CONTENTS

Call for Comment on Standards Proposals

Figure 30.6B
Arc-fault combiner box

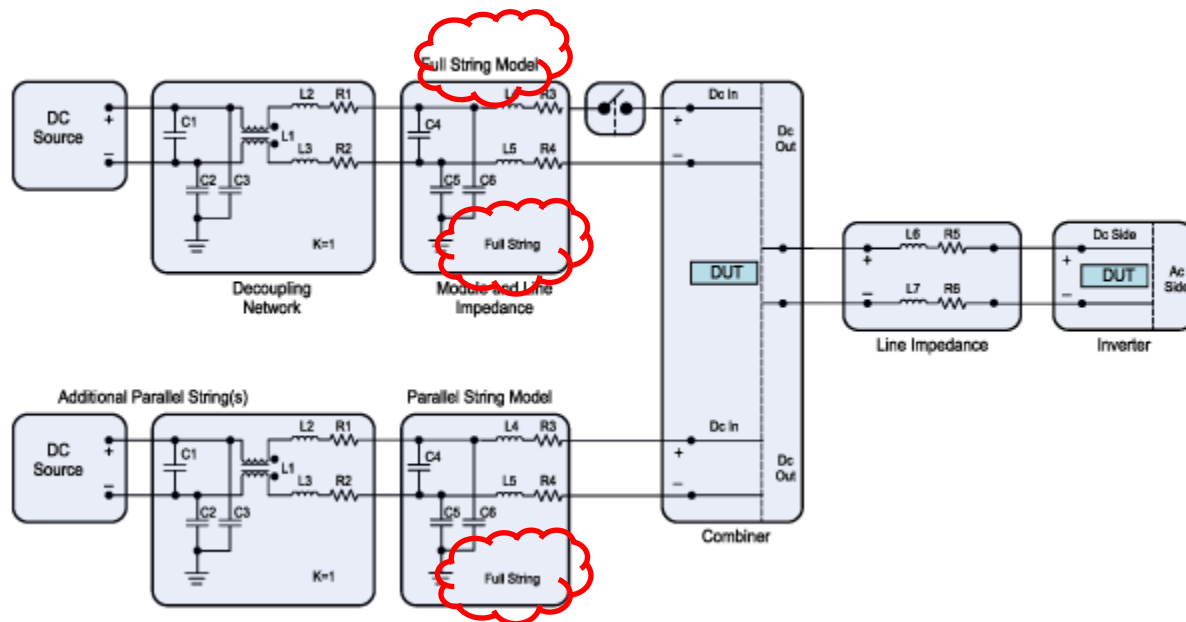
This figure will be revised to change “Full String Model” to “Parallel String Model” and “Full String” to “Parallel String”

Fig. 29.17A.2, Arc-Fault circuit, electronic device connected to two MPPT

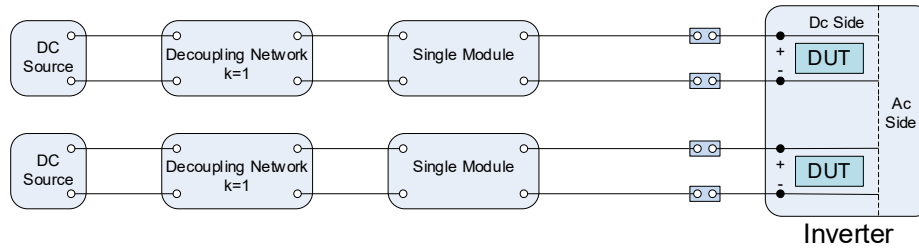
29.7.1 Test setup for electronic devices shall be as shown in Figures 29.17A.1 – 29.17A.4. For each module connected to the electronic device, a separate power supply or solar array/PV simulator shall be used. The power source shall be connected to a decoupling network and line impedance model. The model component values may be altered based on conditions specified in 24.4.

Figure 30.5A.3

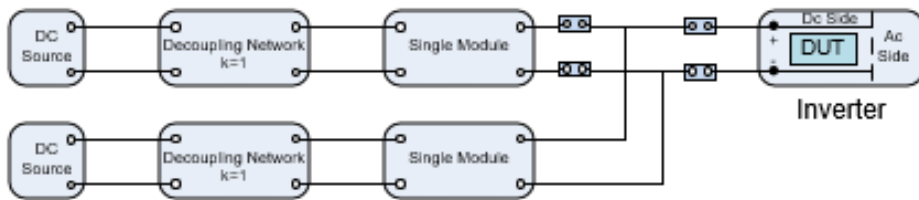
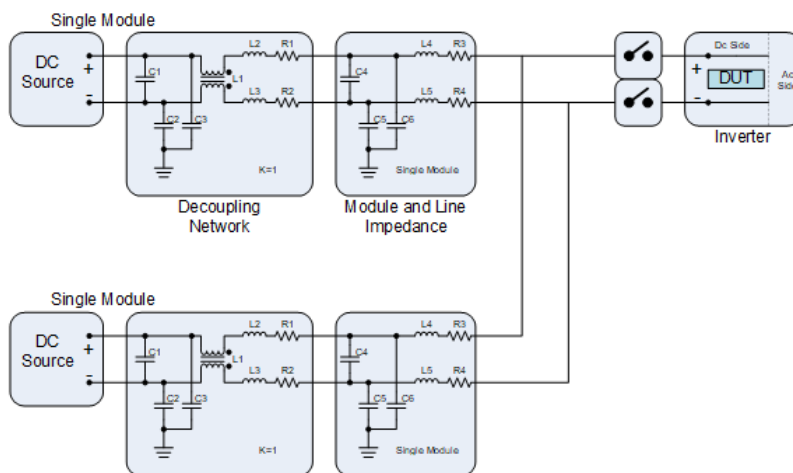
Unwanted tripping circuit, electronic device connected to two modules in parallel
